This document intends to replace the proposal already presented with document ECE/TRANS/WP.29/GRE/2025/2

Proposal for Supplement to the 08 and 09 series of amendments to UN Regulation No. 48

Figure 1

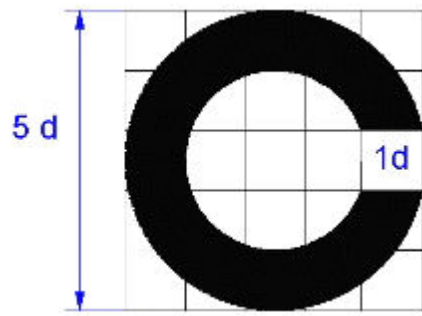
4. In order to have also an objective criteria for the non-identifiability, the size of 12 mm for the character height is added as a footnote. This value is based on informal document GRE-85-16. The visual acuity of a normal observer is defined as the ability to distinguish two objects with a distance of 1' (one arc minute). At a distance of 10 m, 1' correspond to 3 mm. Consequently, a distance of 2.5 mm is too small to distinguish two objects at a distance of 10 m. In another way, if "d" of the Landolt ring correspond to 2.5 mm, the character height is approximatively 12 mm which ensure the non-identifiability at 10 m.

"*In case of doubt, the character height shall not be more than 12 mm."
